PLANNING RATIONALE ADDENDUM #1

Fotenn Consultants Inc. (Fotenn) has been retained by Minto Communities (Minto) to submit and monitor a Zoning By-law Amendment and Draft Plan of Subdivision applications for the lands municipally known as 936 March Road in the Kanata North community of the City of Ottawa (subject lands).

Figure 1: Revised Development Concept Plan

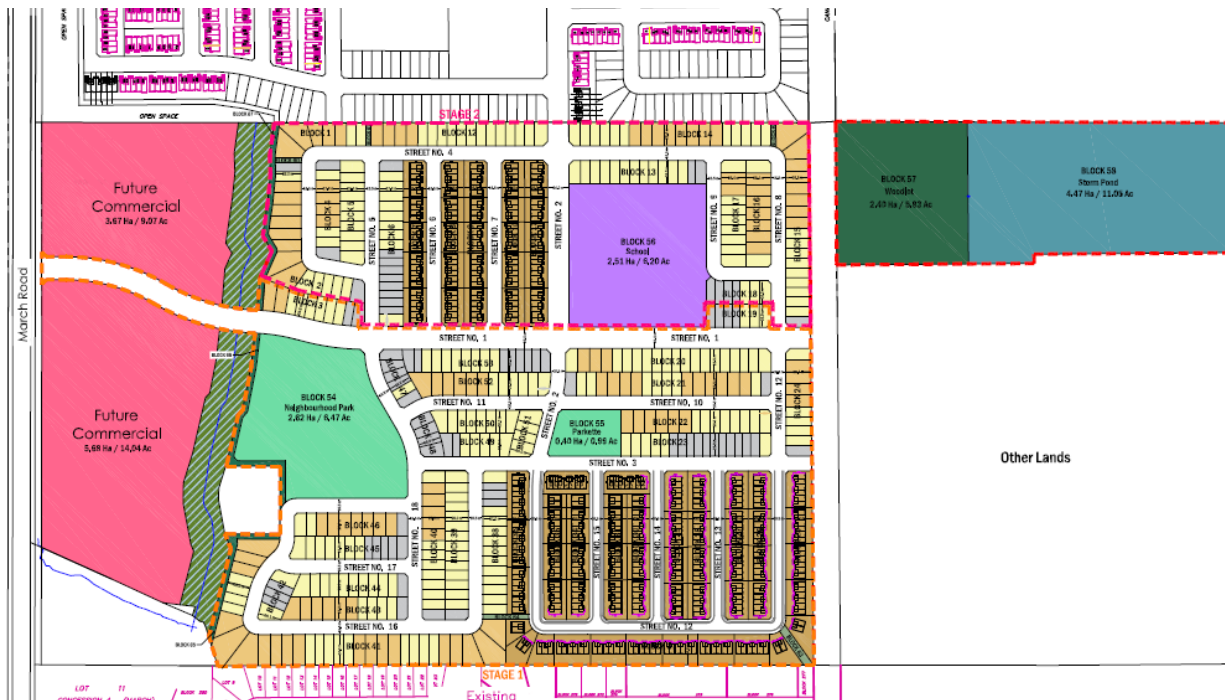
Please include some residential multi-unit block (in addition to townhomes) within the subdivision, ensure that the total breakdown meets the minimum density of 36 units per net hectare (not 34), and contain at least 30 percent single and 10% apartment as per the Official Plan policy 3.6.1 (14). Please revise the planning rationale to reflect the change.

The revised plans now reflect a minimum density of 38 units per net hectare, meeting the density targets contemplated in the Official Plan. The Plan of Subdivision generally reflects the Kanata North CDP Demonstration Plan and includes 420 townhouse units, defined as “multi-unit residential” in the CDP. As per section 4.3.2 in the KNCDP, the multi-unit residential designation has been defined as traditional townhouses, stacked and back-to-back townhouses along with low-rise apartments, contributing to the mix of uses in the area. While this Plan of Subdivision does not contain plans for multi-residential dwelling units such as apartments, there exists opportunities elsewhere in the expansion area to accommodate this built form, which would be more compatible with the neighbouring planned context.

Figure 2: Typical Lotting Standard and Measurements: (Left) 30' Single Detached Homes (Right) 36' Single Detached Homes

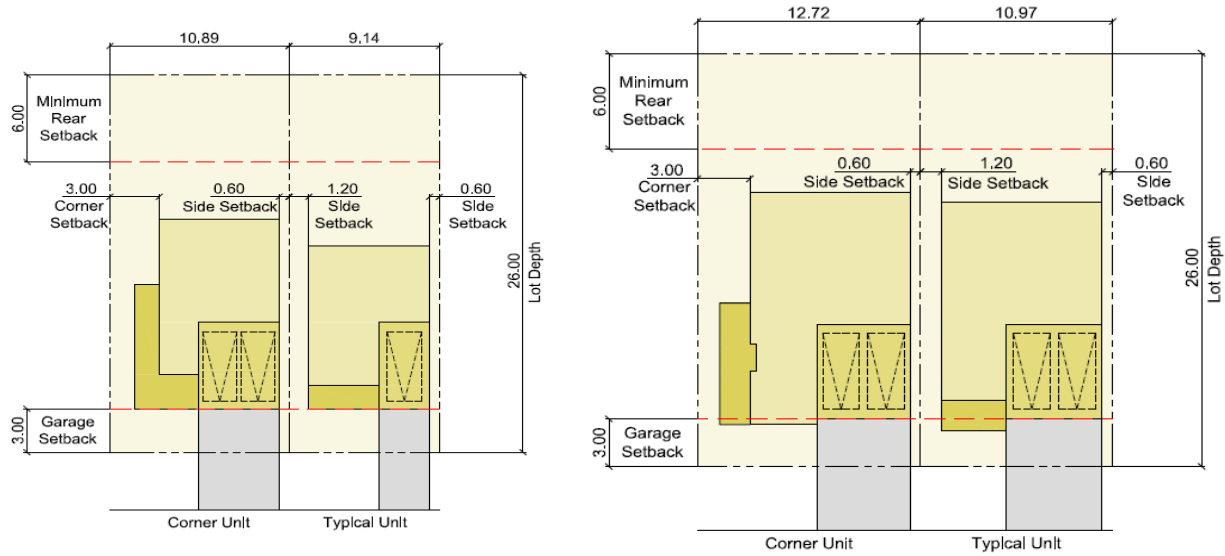
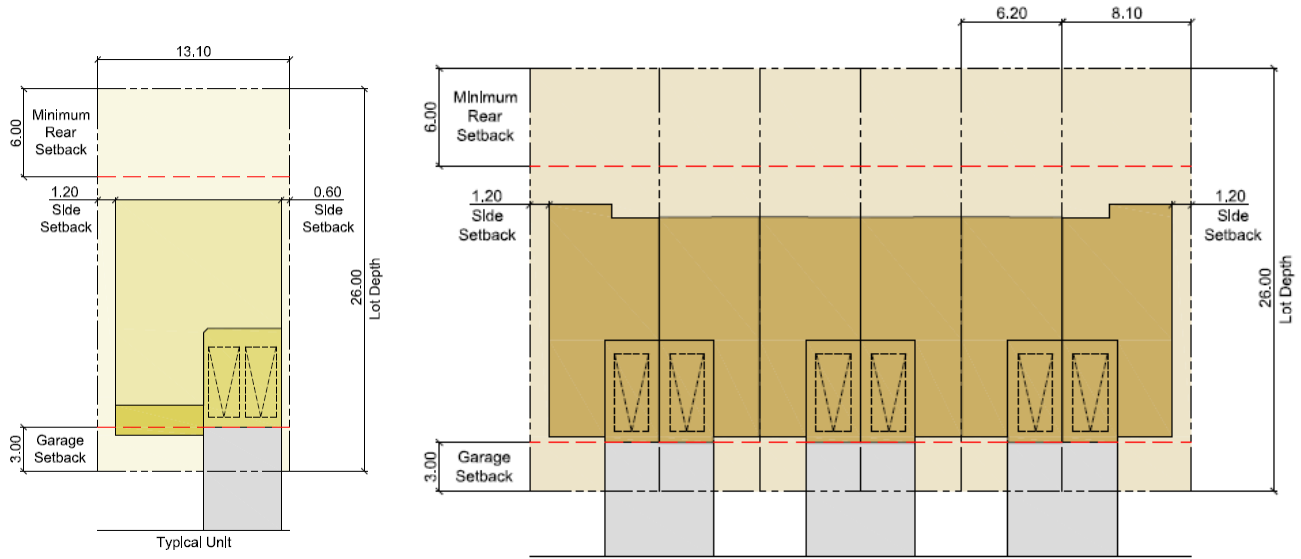
Please confirm what exceptions are required from the R3Z zoning. If required, please include any required driveway width exception for corner units with double car driveway.

As a result of the current lot configuration, Minto is proposing the R3ZZ zoning with an exception similar to what was implemented in the Mattamy Lands in Kanata, South of Palladium Drive. The exception would include the following performance standards:

- / **Zone requirements for detached dwellings:**
 - minimum lot area is 220 m²
 - minimum lot width is 8.8 m
 - minimum front yard setback is 3 m for the principle building and for an attached garage
 - minimum combined interior side yard setback is 1.8 m with a minimum of 0.6 m on one side
 - minimum corner side yard is 2.5 m
 - maximum lot coverage is 55%

- / **Zone requirements for semi-detached and townhouse dwellings:**
 - minimum lot area is 137 m²
 - minimum lot width is 5.5 m
 - minimum front yard setback is 3 m for the principle building and attached garage
 - minimum side yard is 2.5 m
 - minimum rear yard setback is 6 m,
 - maximum lot coverage is 65%
 - maximum building height is 12 m

The typical layouts are included below:
